RESOLUTION NO. 16-34

A RESOLUTION OF THE MAYOR AND CITY COUNCIL OF THE CITY OF MARICOPA, ARIZONA, DECLARING AS A PUBLIC RECORD THAT CERTAIN DOCUMENT FILED WITH THE CITY CLERK AND ENTITLED "2016 AMENDMENTS TO CHAPTER 14 SUBDIVISION REGULATIONS" OF THE MARICOPA CITY CODE, RELATING TO THE ESTABLISHMENT OF RULES AND REGULATIONS FOR THE DEVELOPMENT OF SUBDIVISIONS WITHIN THE CITY OF MARICOPA AND AMENDING CERTAIN PROVISIONS OF SECTIONS 14-1-6 THROUGH 14-7-3 OF THE MARICOPA CITY CODE.

2016 Amendments to Chapter 14 Subdivision Regulations

Figure No 6 - Parkway Road Section

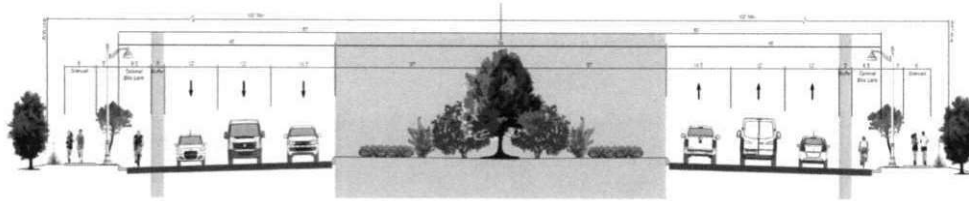
33. Sec. 14-6-8: Added Figure 6-17.

B.O.C. Width	Median Required	Median Width	Curb Type	# of Travel Lanes	On-Street Parking Required	Bike Lane Required	Sidewalk	Landscaping Strip
200'	Yes	74'	Inside vertical curb, outside vertical curb and gutter	3 travel lanes each side, plus turning lane	No	Yes	Detached	5' wide at B.O.C.

- Number of travel lanes is for each direction.
- All travel lanes shall be a minimum of twelve (12) feet in width unless otherwise noted within this section or as required by the City Engineer.
- Sewer and water utilities shall be located under the pavement or within a sewer easement.
- Dry utilities shall be located within the P.U.E. outside the ROW.
- Sidewalks (S/W) shall be constructed of portland cement concrete.
- Back of curb (B.O.C.).
- Back of sidewalk (B.O.W.).
- Refer to latest MAG standard for curb and gutter details.
- If a multi-use path is required per the latest adopted Parks Trails and Open Space plan, refer to Figure 1, which is required in addition to this street section and is to be placed within a sidewalk and landscape easement if located beyond the required ROW.
